Anderson Ground Storage Tank No. 1 Painting and Rehabilitation Project
SAWS Job No. 13-0129
Solicitation No. B-15-020-DD

ADDENDUM No. 4

July 13, 2015

C-101

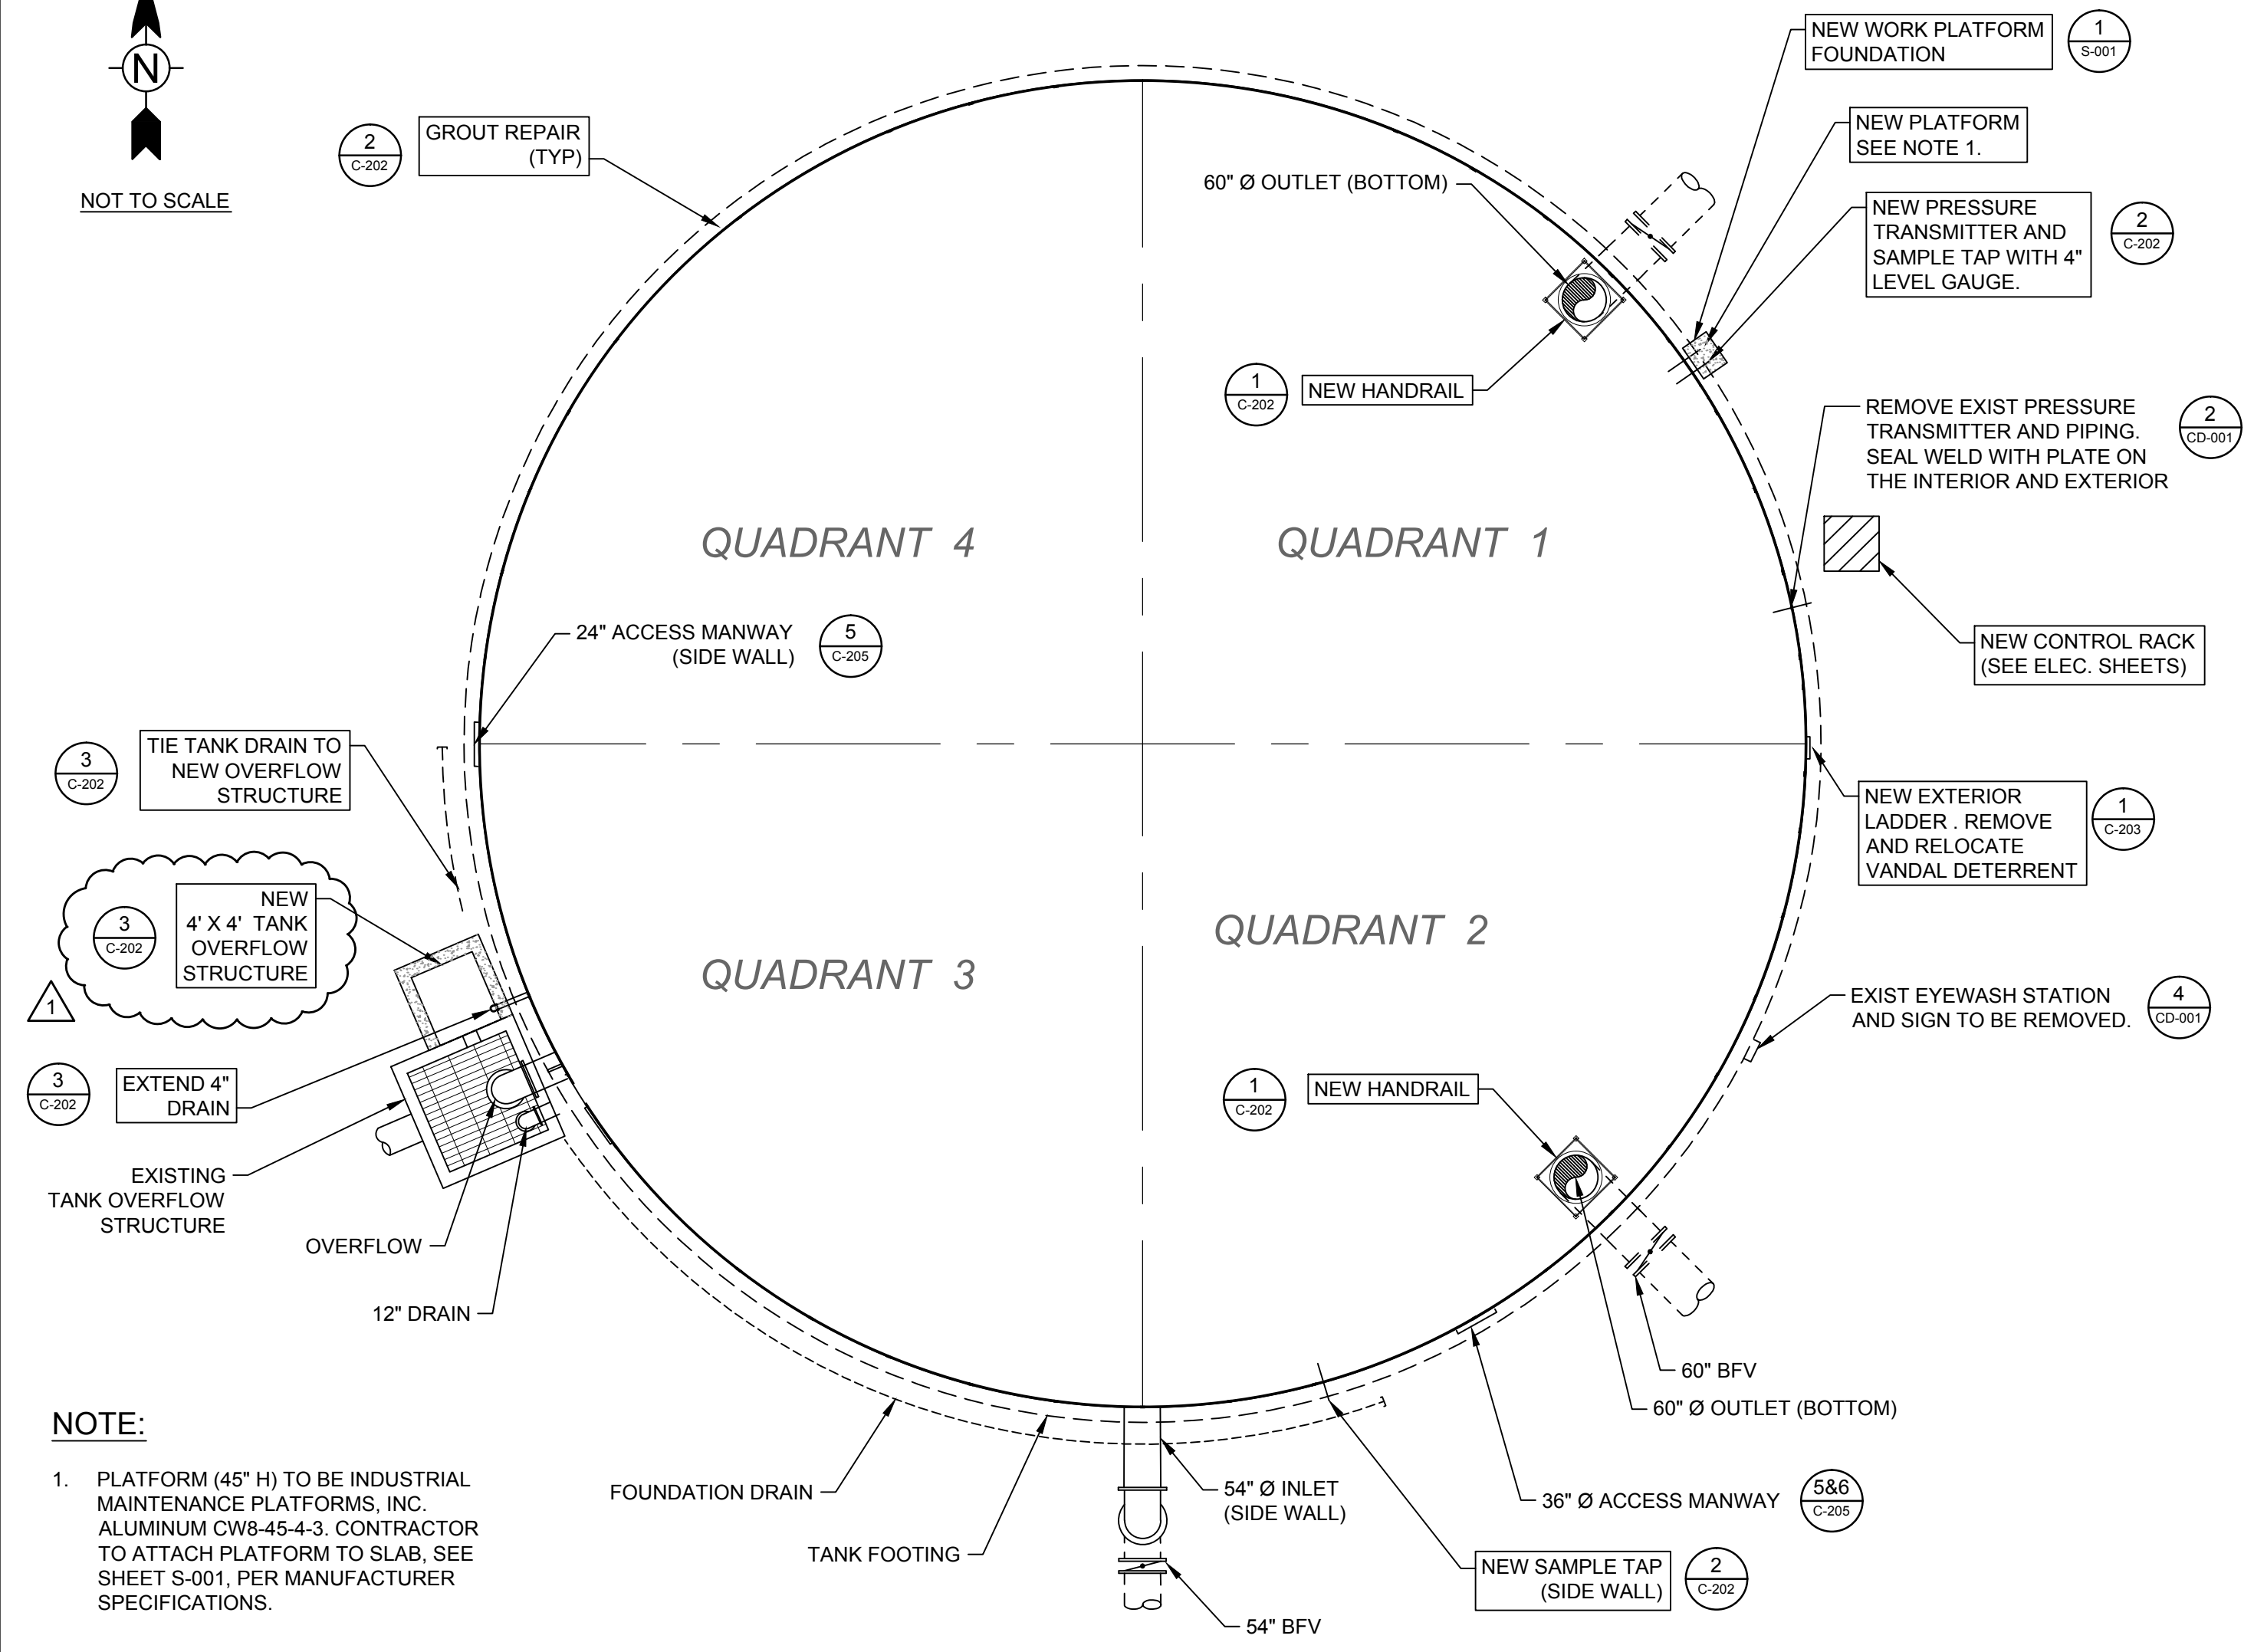
3.1 Sheet C-101

- Revised New 4’ X 4’ Tank Overflow Structure sheet reference.

4.9 C-101 note "New 4x4 Tank Overflow structure" states to see sheet S003. There is no S003.

Response: Revise C-101 note to read: "NEW 4' X 4' TANK OVERFLOW STRUCTURE SEE SHEET C-202". Please see 3.1 of this addendum under Modifications to Plans.

C-201

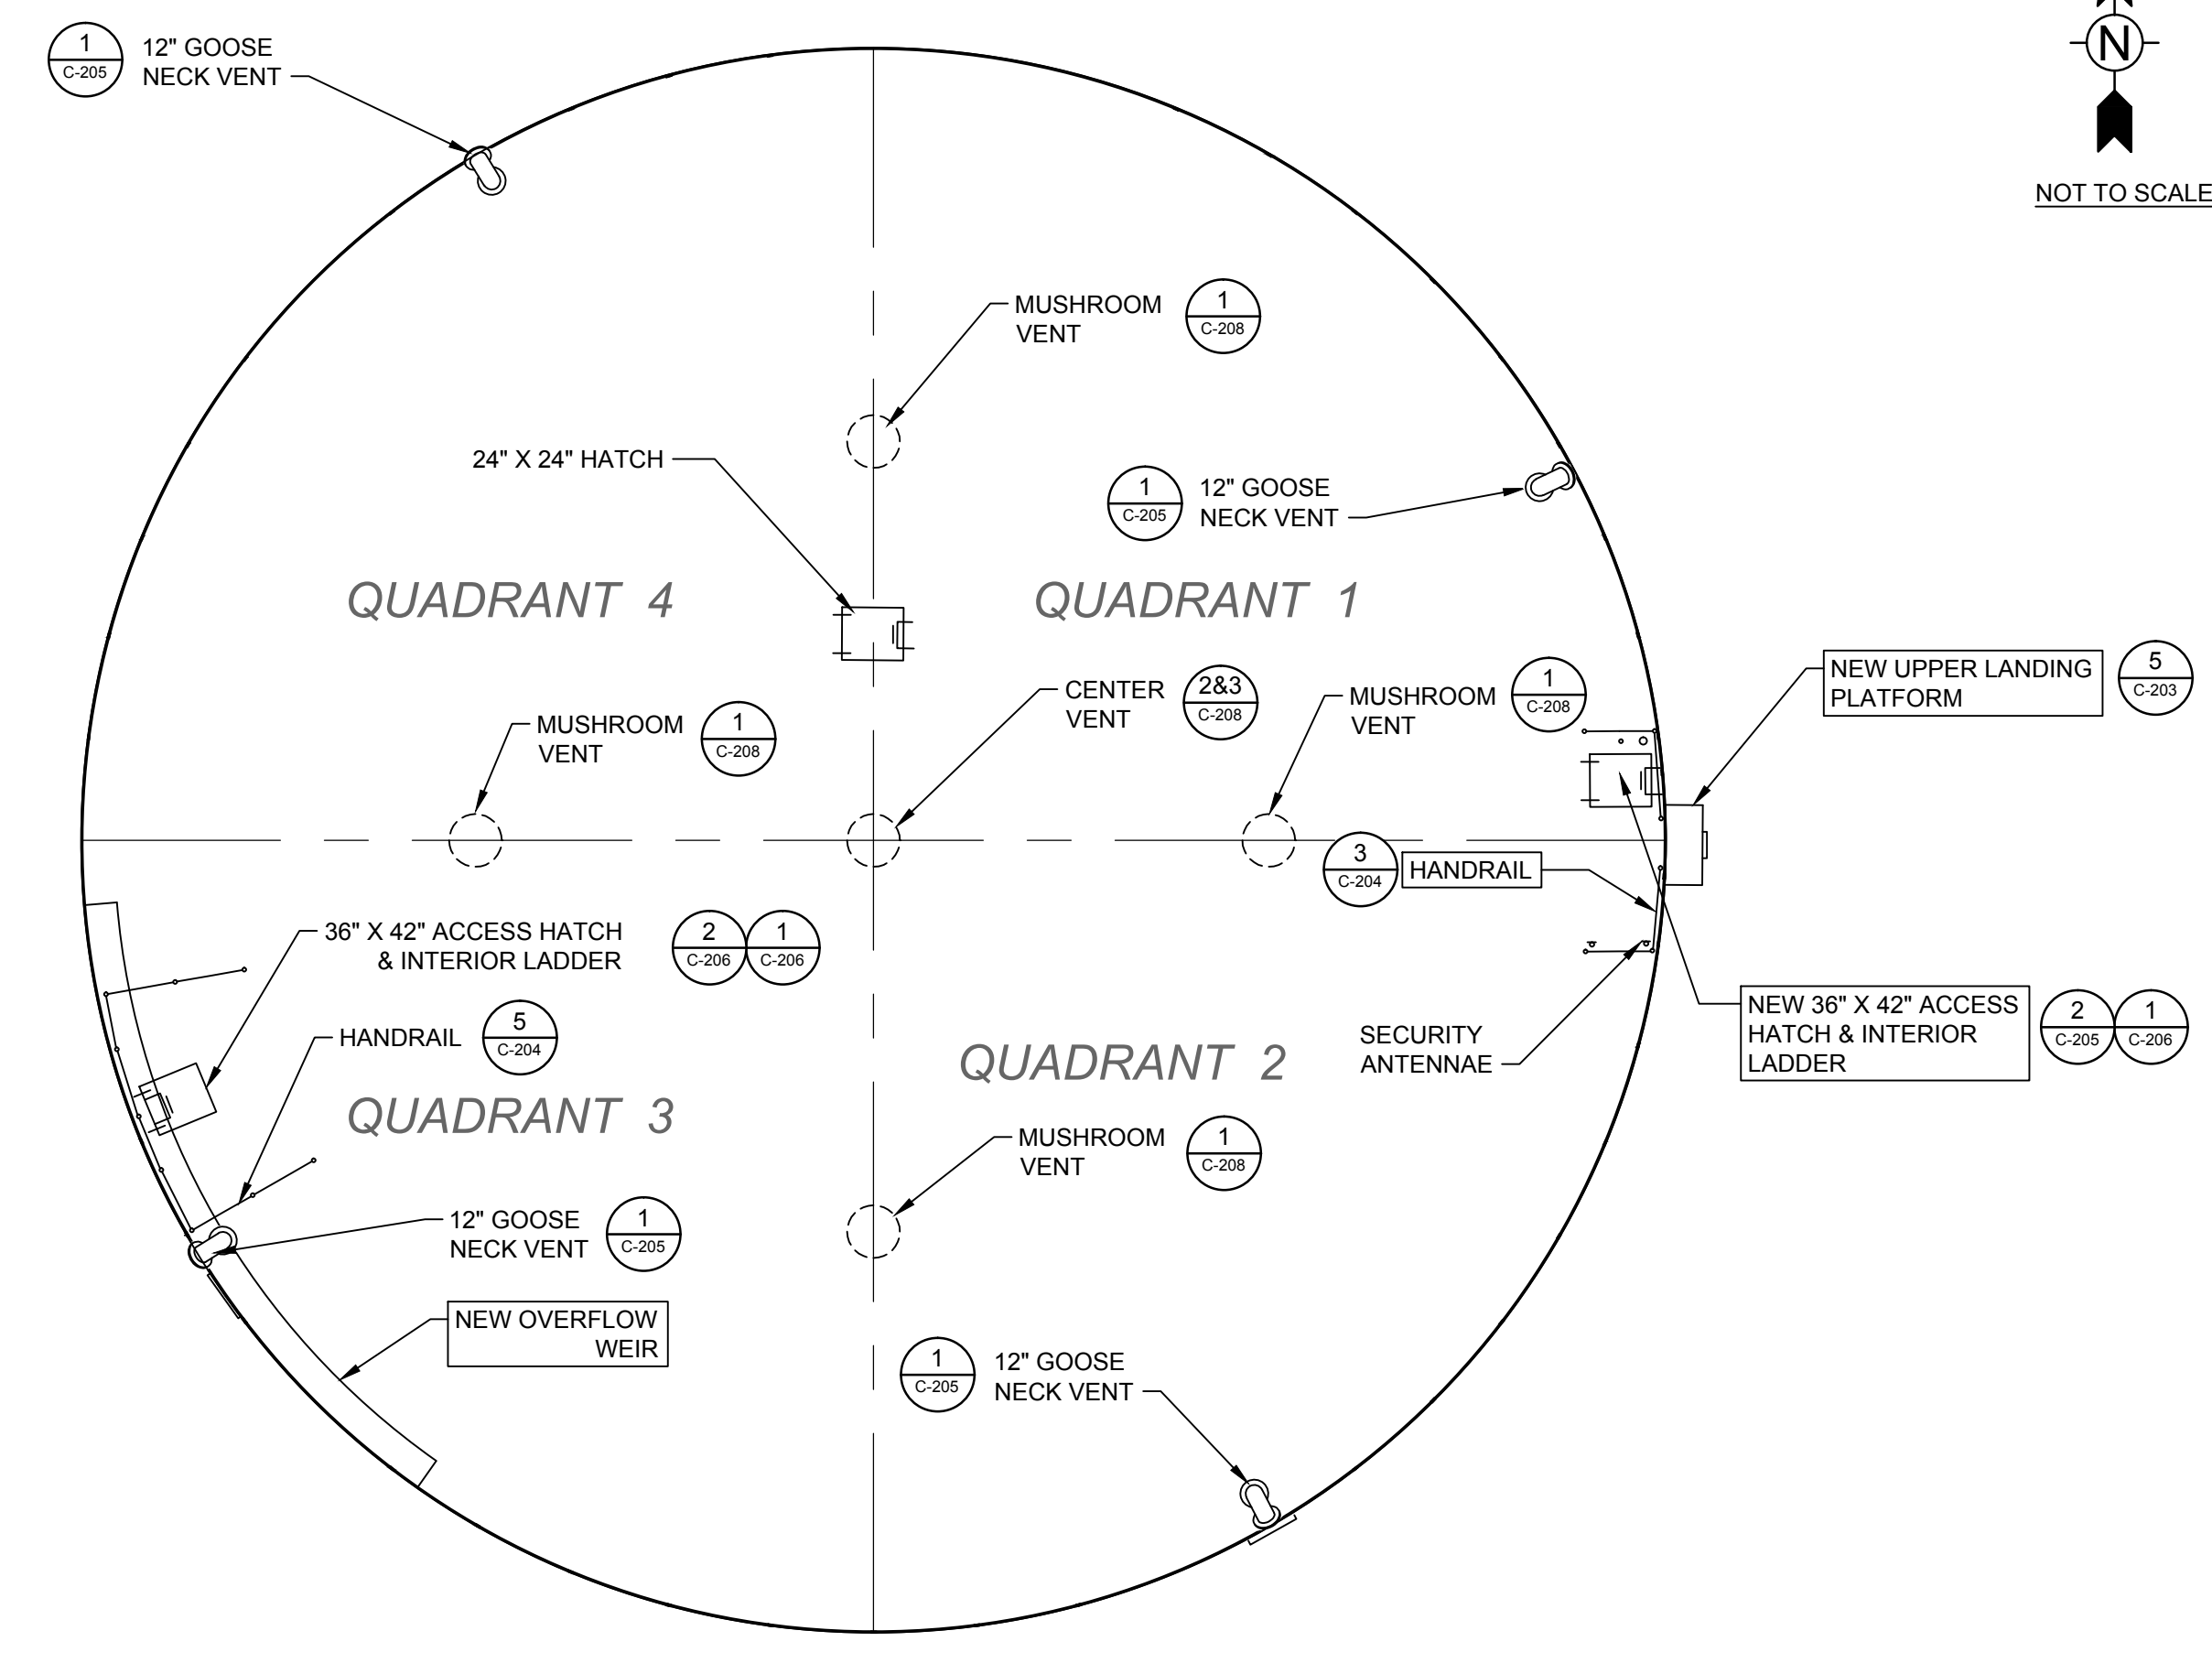
3.2 Sheet C-201

- Correction to size of overflow structure.

1 TANK INTERIOR LADDER
SCALE: NOT TO SCALE

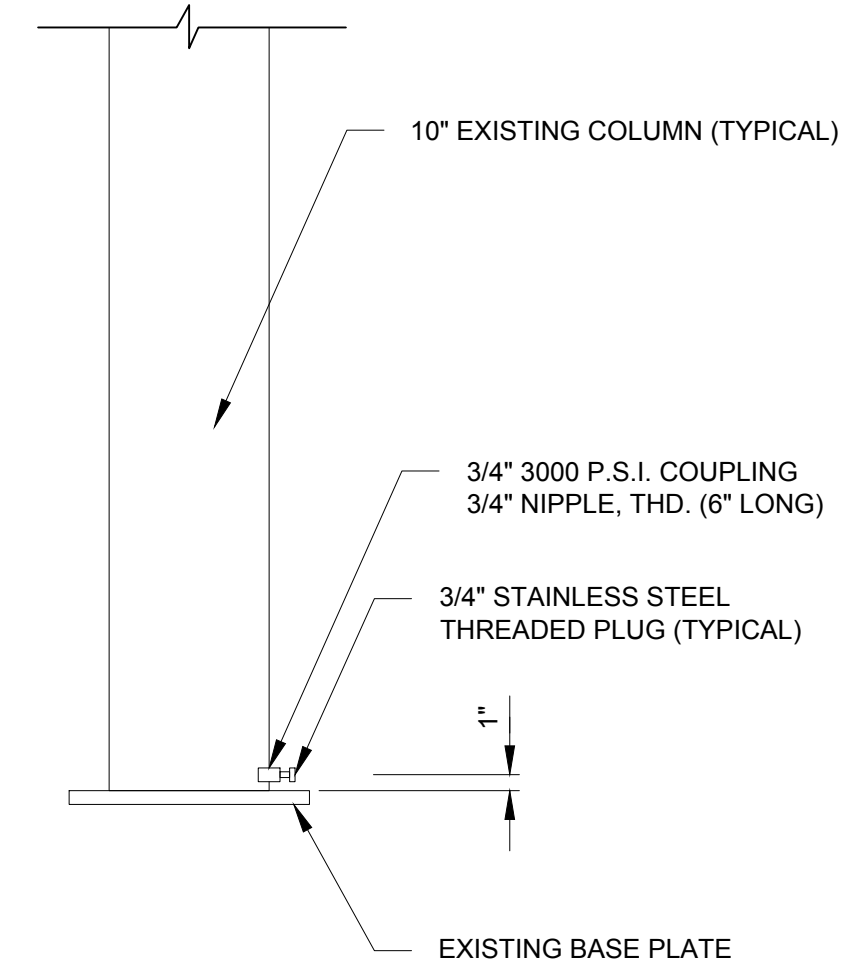
- 4.5 Drwg C-206 has two numbers for cable safety rail- 6116502 and 6116005. Which one is it?
Response: Contractor is to provide a complete DBI/SALA vertical fall arrest system for each ladder to include all necessary brackets, cables, sleeves, guides, and miscellaneous hardware to provide for a fully functional system. Refer to revised sheet C-206 for further details.

NOTE: PROVIDE COMPLETE DBI/SALA VERTICAL FALL ARREST SYSTEM WITH 3/8" S.S. CABLE WITH GUIDES AND S.S. BRACKETS AND S.S. HARDWARE FOR ALL EXTERIOR AND INTERIOR LADDERS. INTERIOR LADDERS SHALL HAVE INSULATED CONNECTORS. PROVIDE (2) FULL BODY HARNESSSES (BUCKLE-TYPE WITH FRONT D-RING).*
